2018 Mercedes Benz E63S AMG 4MATIC Sed (213.089) V8-4.0L Turbo (177.980)

REPLACE COVER FOR POSITIVE POLE ON STARTER BATTERY

Recall Campaign Bulletin

Campaign No. 2018110002, November 2018

Figure 1

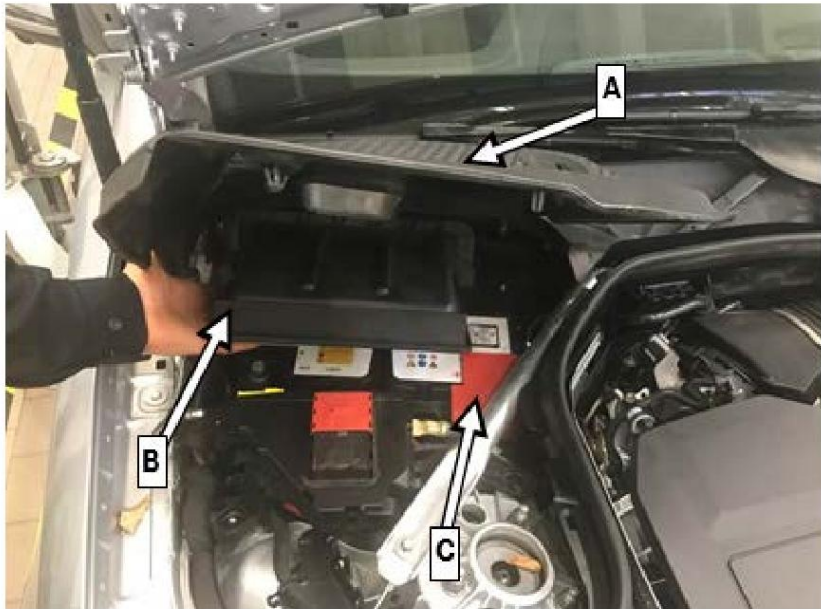
Daimler AG ("DAG"), the manufacturer of Mercedes-Benz vehicles, has determined that on certain Model Year ("MY") 2018 C-Class (205 platform) and E-Class vehicles (213 platform), an incorrect cover for the starter battery may have been installed which provides insufficient cover for a live electrical wire. Therefore, in the event of a crash which results in substantial deformation of the strut brace above the battery, the strut brace could contact an uncovered live electric wire which could lead to a short circuit. A short circuit could lead to an increased risk of fire. In this case, the on-board electrical system might not be able to support post-crash functions (e.g. emergency door unlocking or activation of hazard warning lamps may not be available). However, unlocking and opening of the doors from the inside are not affected. An authorized Mercedes-Benz dealer will replace the battery cover on the affected vehicles.

1. Lift cover (A, Figure 1).
2. Lift interior air filter (B, Figure 1).
3. Replace cover for positive pole (C, Figure 1) on starter battery.
